TV Products Service Bulletin

Model: KPR-46CX25/46EX25/53EX20

No. 71

Subject: R-697 Omitted From Service Manual **Date:** February 8, 1991

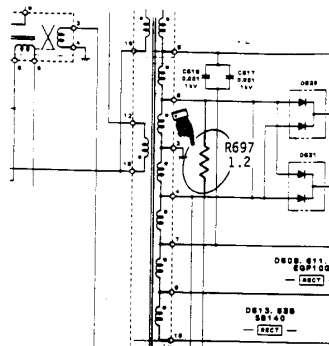
Resistor R-697 was omitted from the schematic.

Solution: Please add Resistor R-697 between pin 6 of T-605 and pin 2 of T-607 on the "G" Board to your service manual schematic.

Ref. No.	Description	Part Number
R-697	1.2 Ohm 1/6 Watt Carbon Resistor	1-249-382-11
